EXPEDITED MONTGOMERY COUNTY HISTORIC PRESERVATION COMMISSION STAFF REPORT

Address: 7207 Thornapple Place, Chevy Chase Meeting Date: 11/13/2019

Case Number: 35/96-19A REVISION

PROPOSAL: Building addition

Detail: Add New window in existing dommer

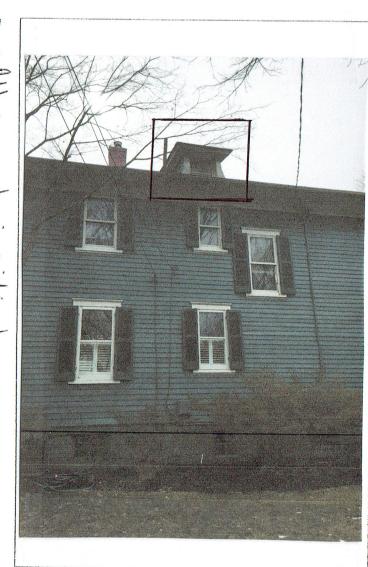
- Removal of the existing louvered vent from the dormer on the north (left) elevation of the historic house and installation of a fixed six-lite TDL wood window in its place.
- Installation of steel bilco doors for egress on the south (right) elevation of the previously approved rear addition.

Staff recommends that the Commission <u>approve</u> the HAWP application only for alterations to the main house under the Criteria for Issuance in Chapter 24A-8(b), having found that the proposal will not substantially alter the exterior features of the historic resource and is compatible in character with the district and the purposes of Chapter 24A;

STITE PLAN

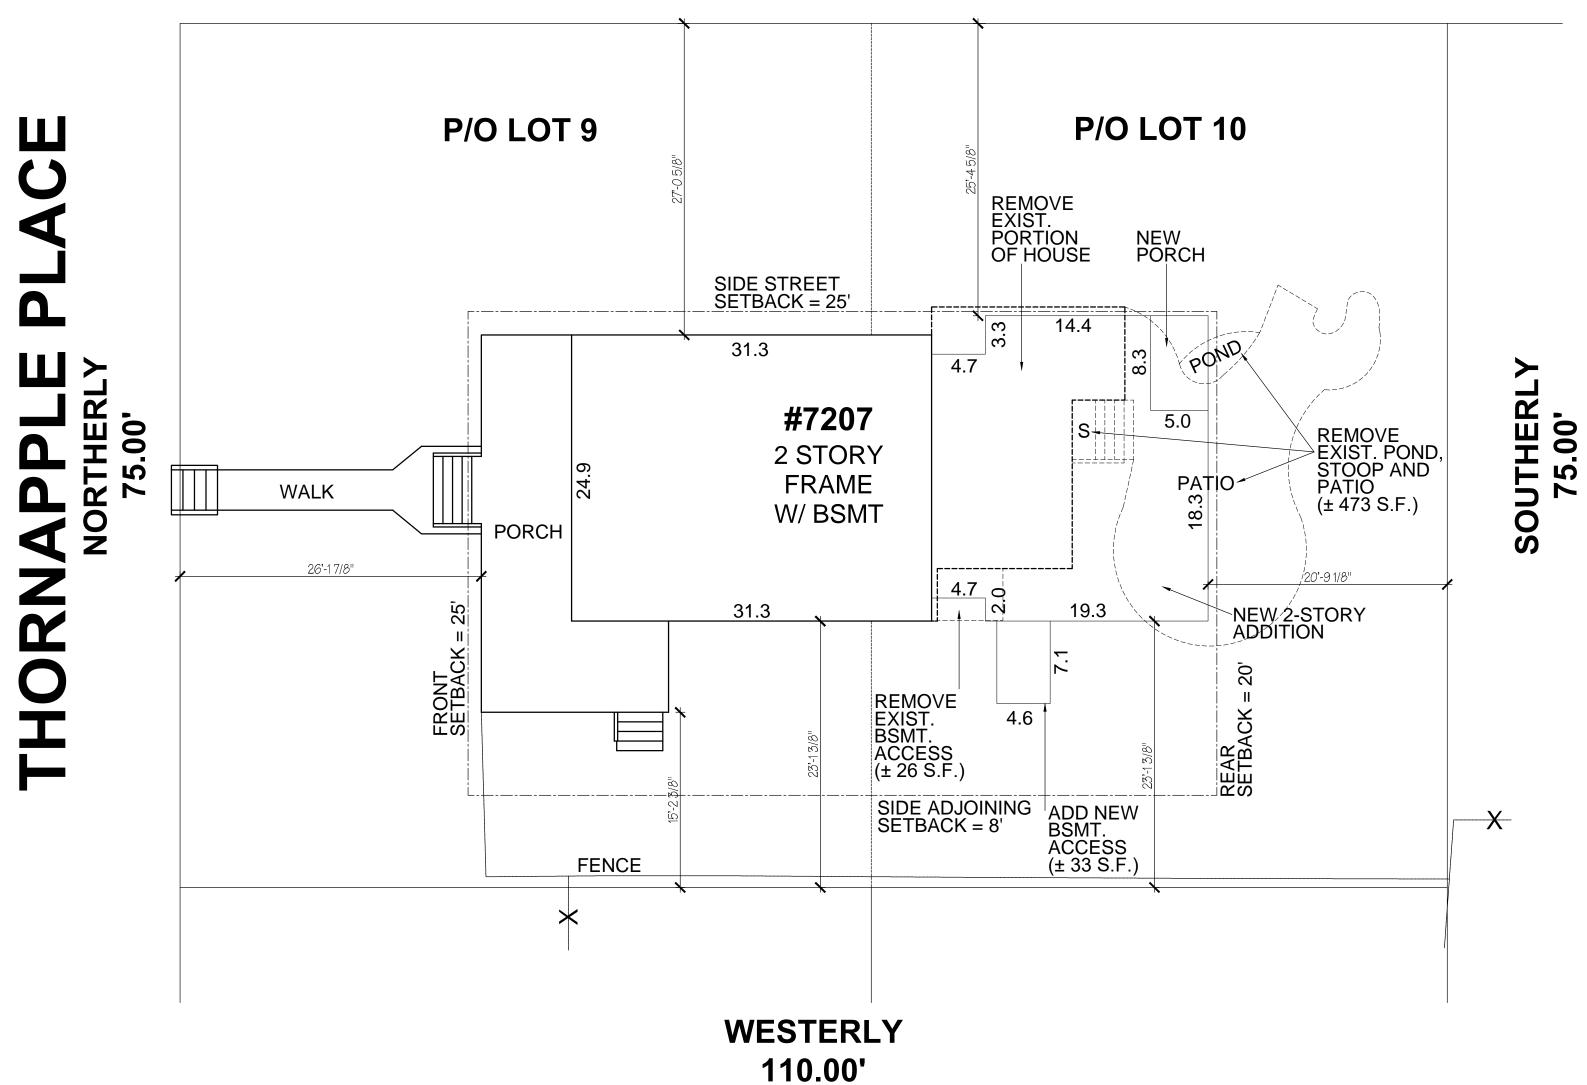
ADDED BILCO DOOR

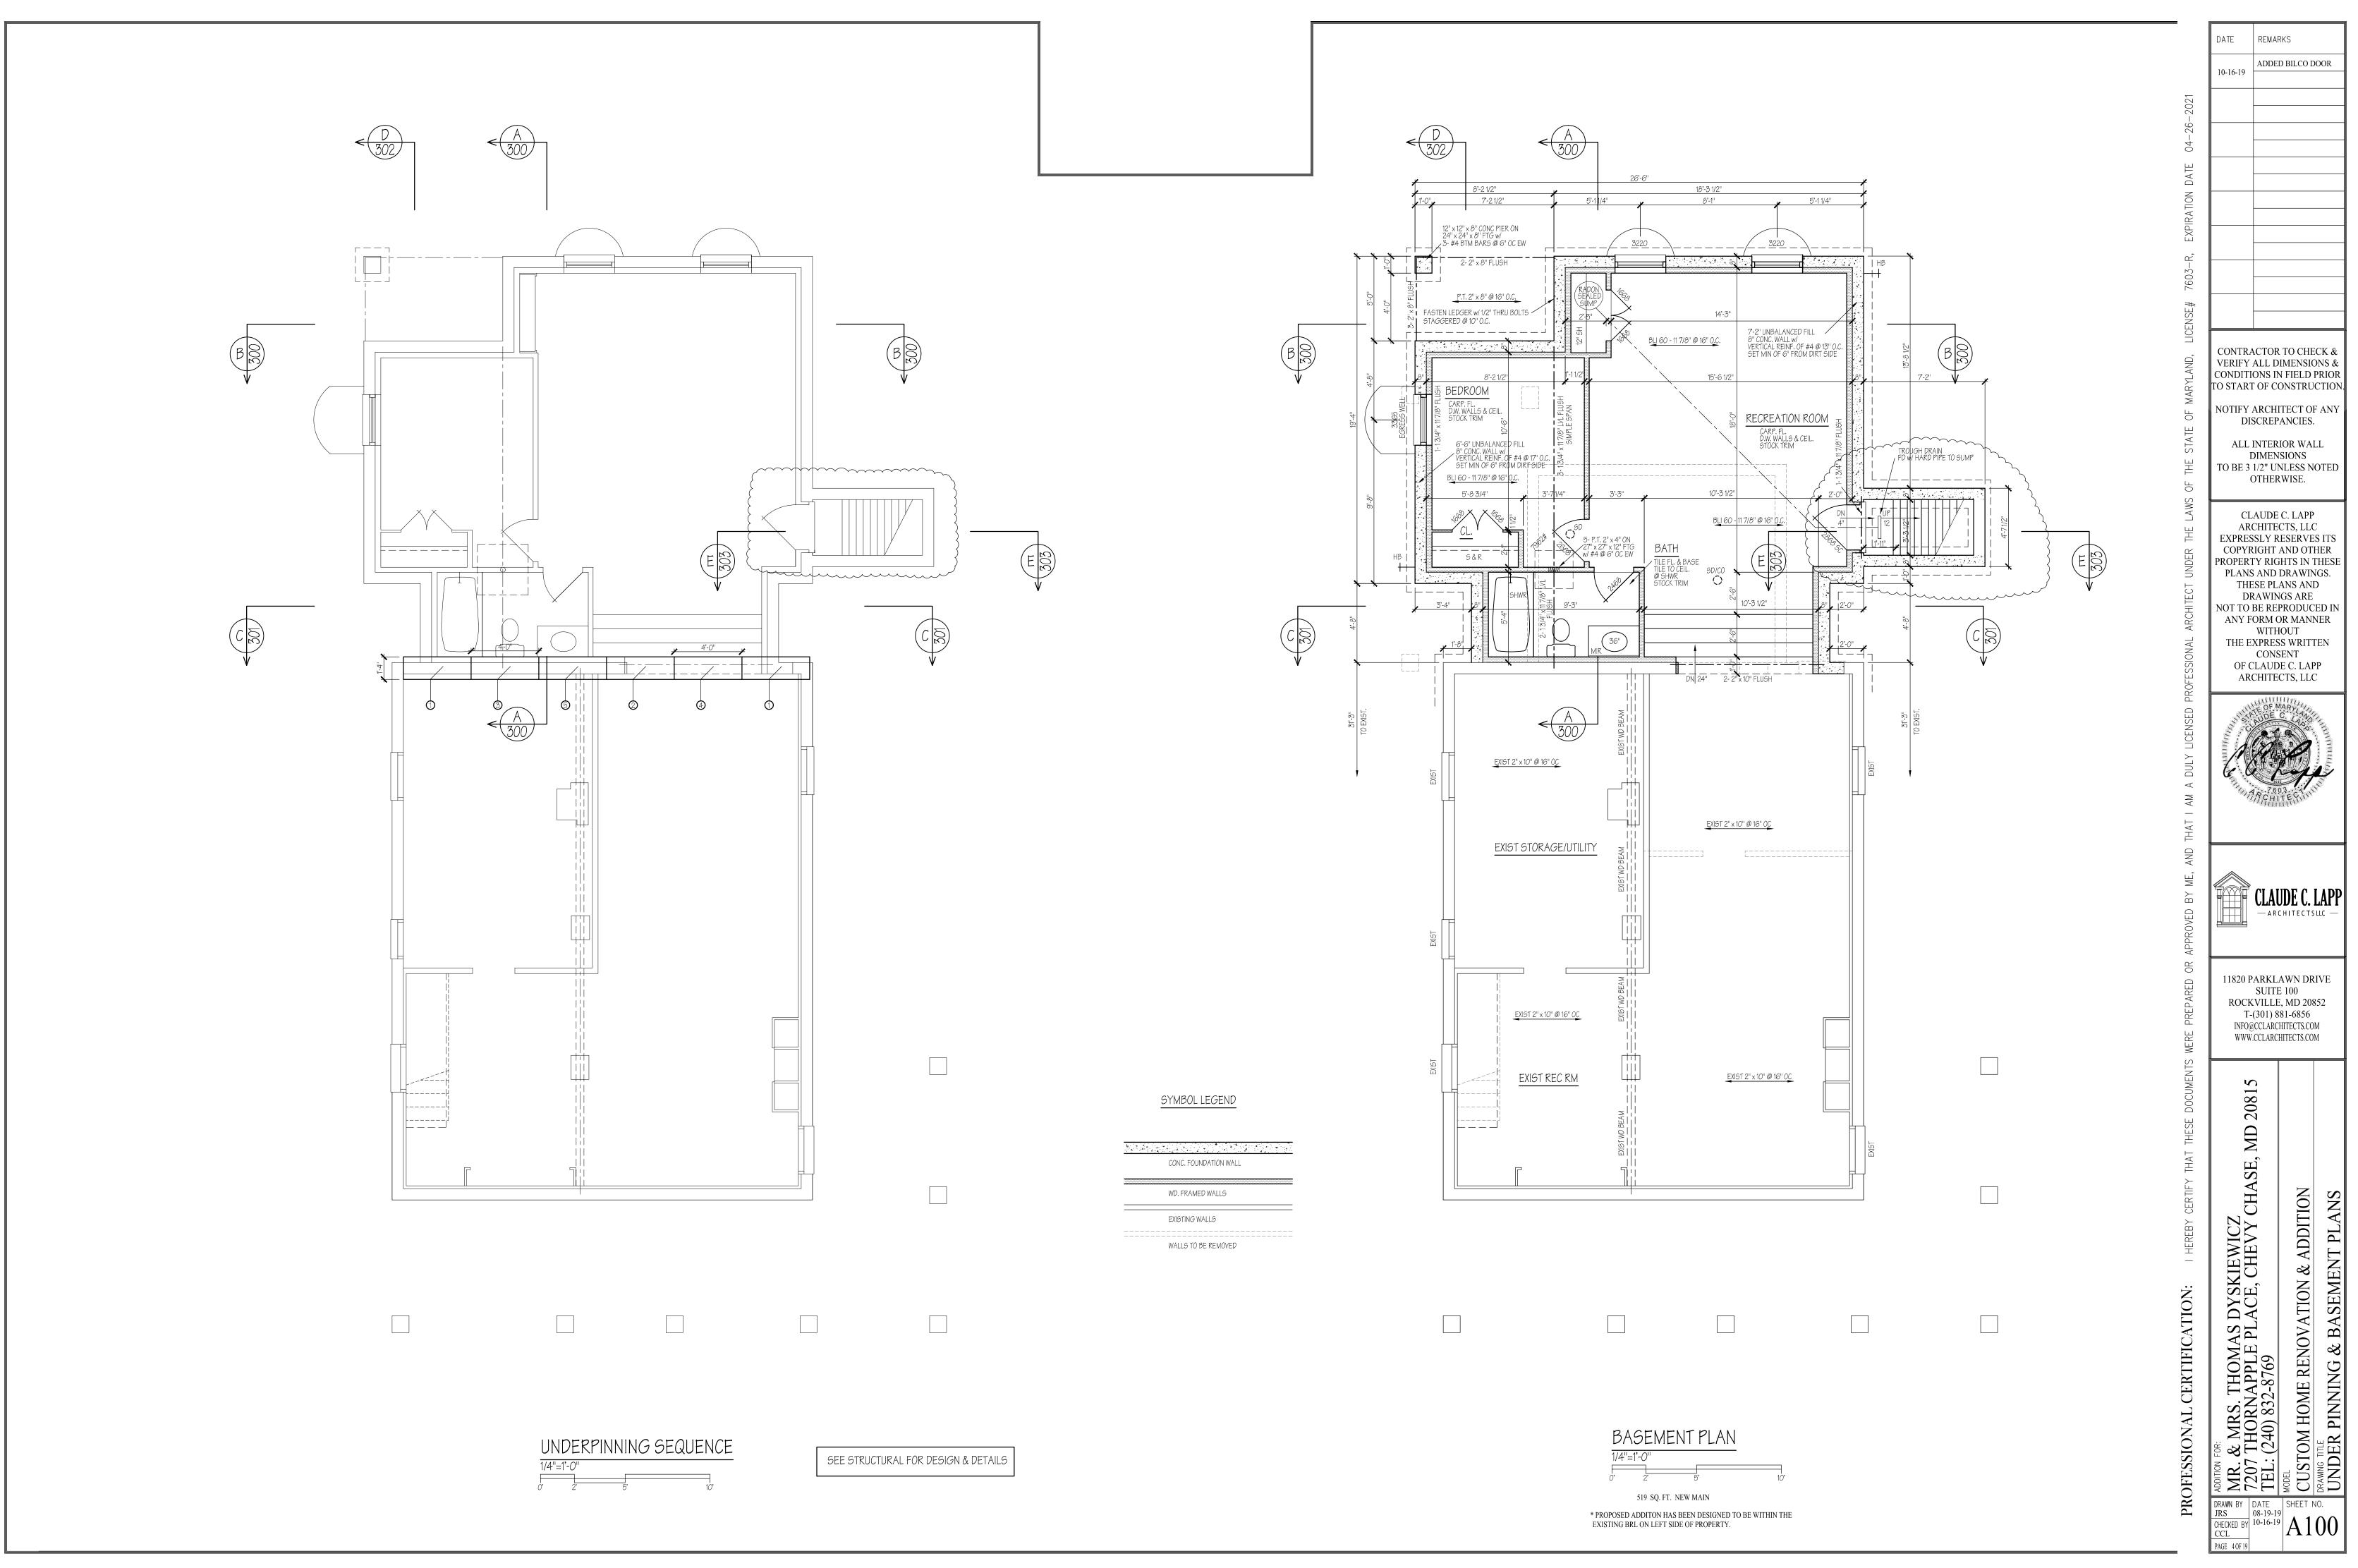
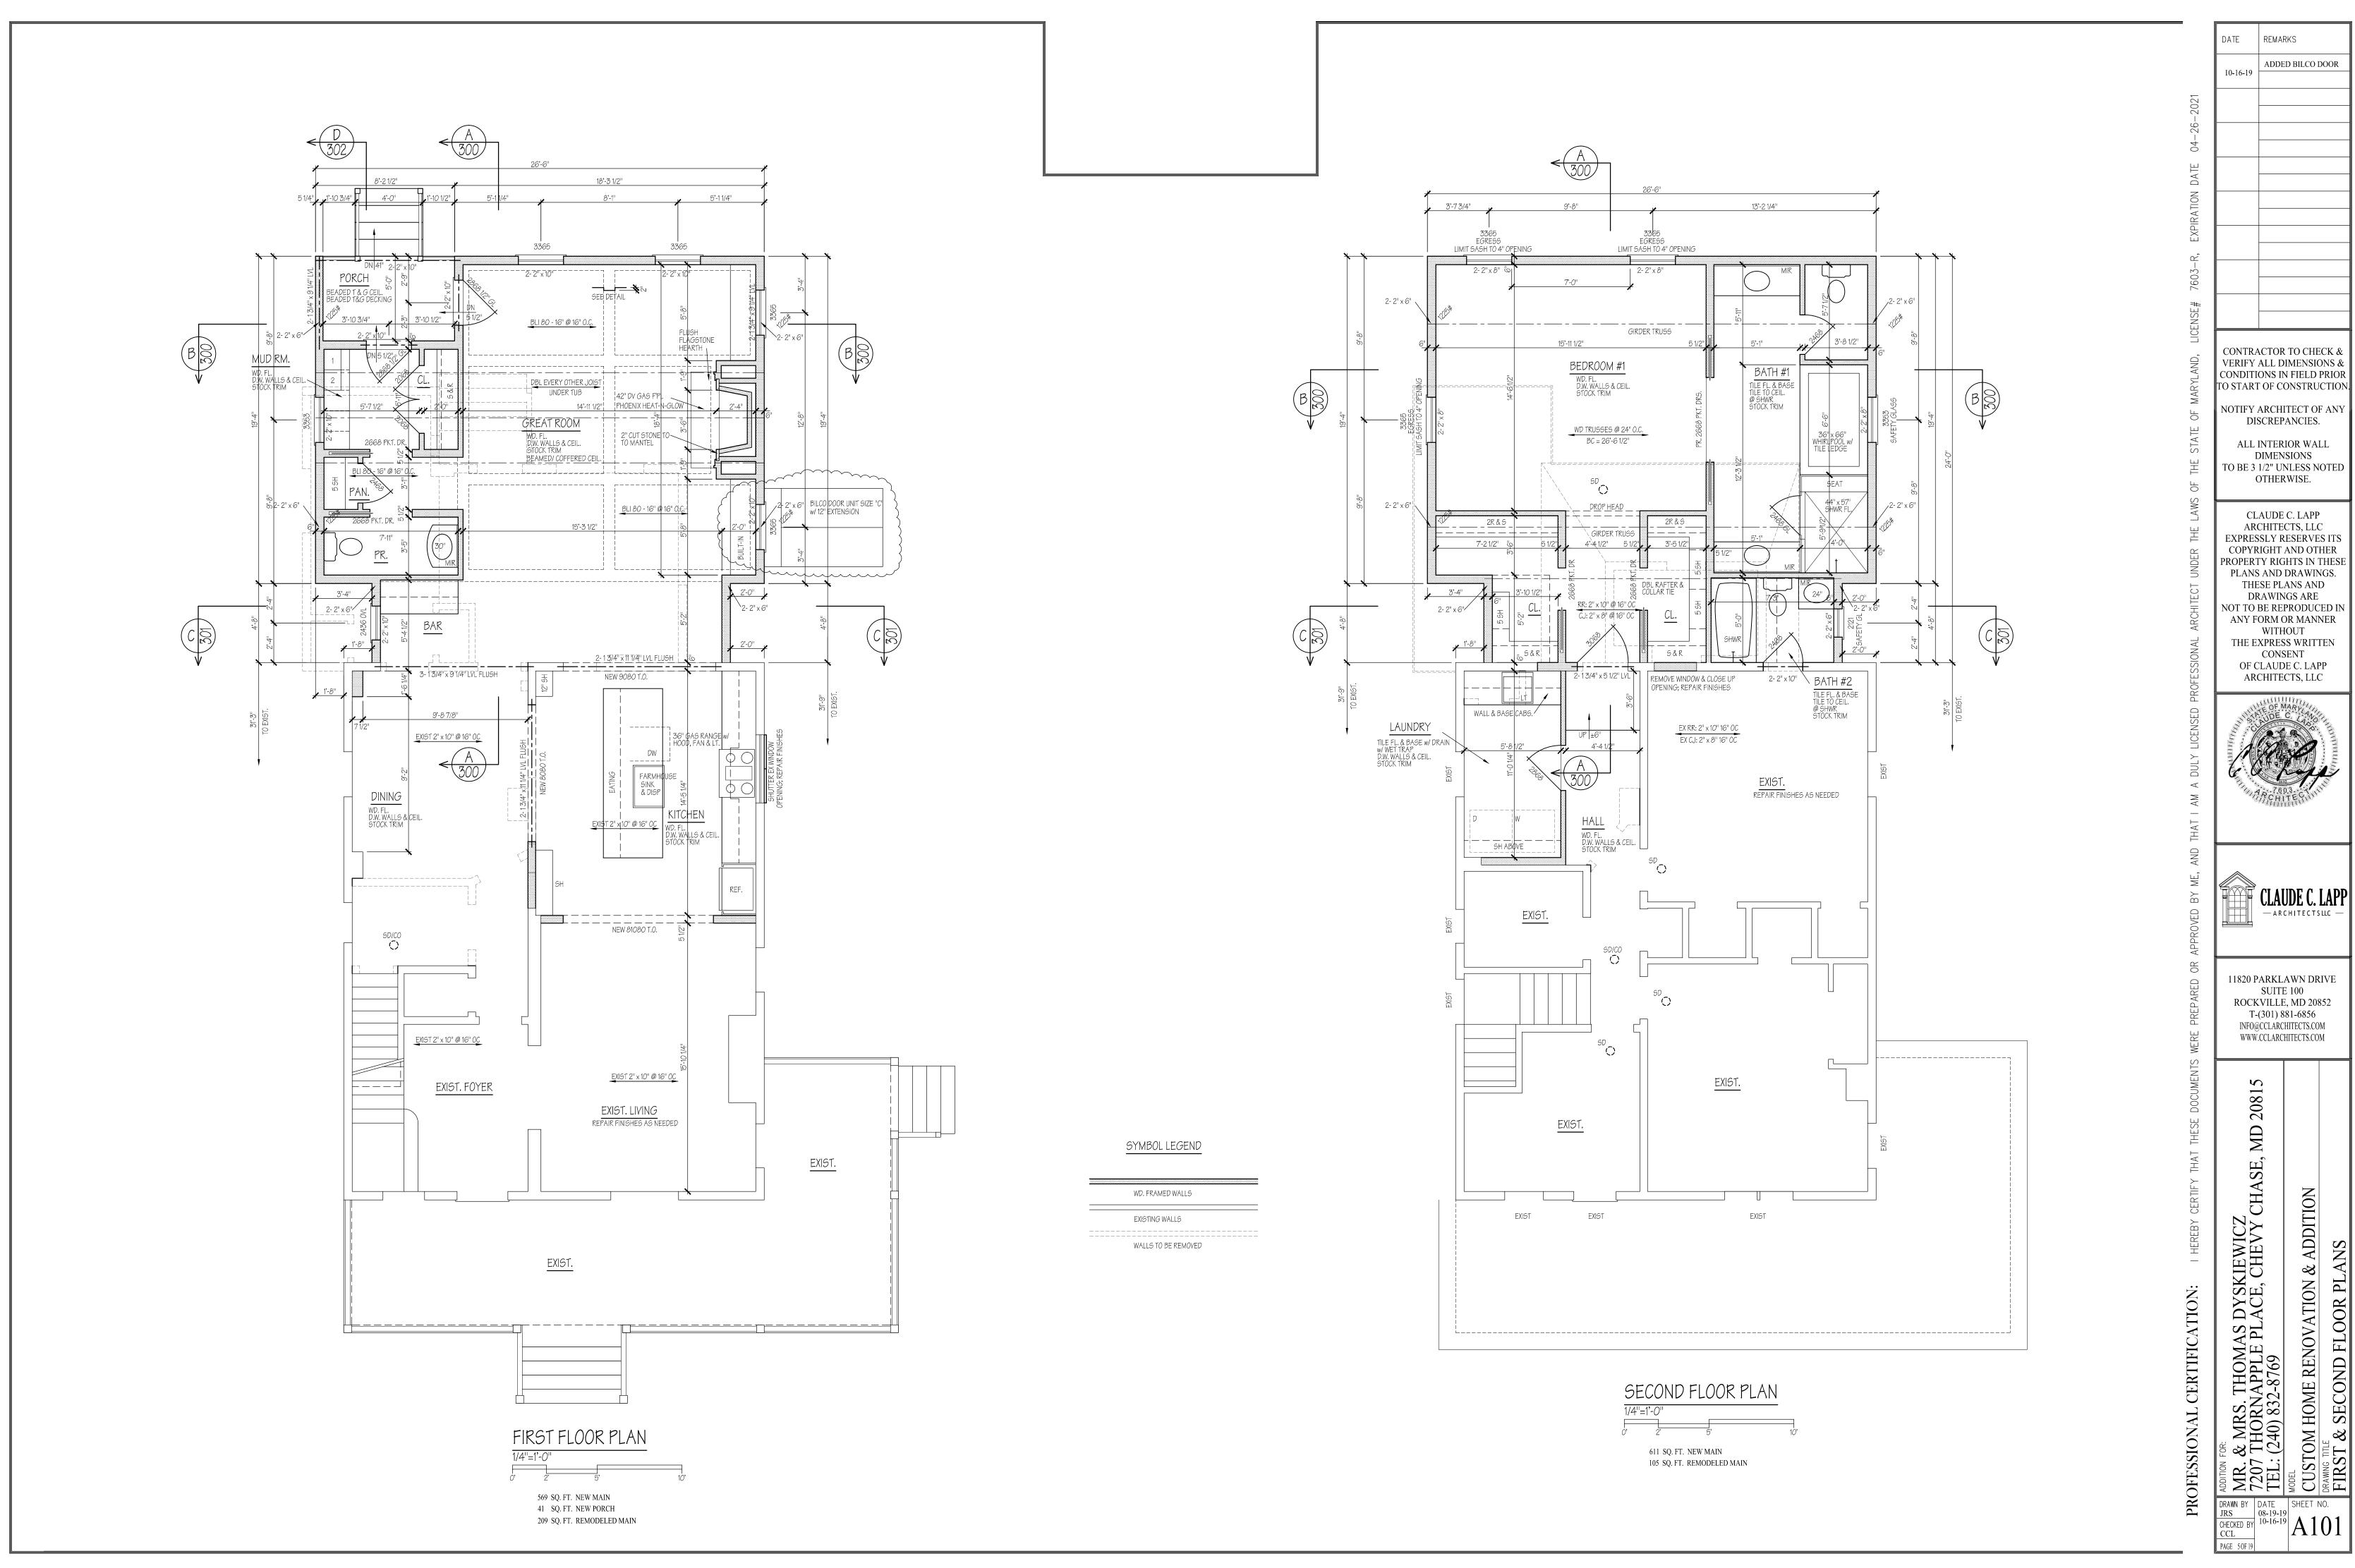
ADDED BILCO DOOR REPLACED DORMER
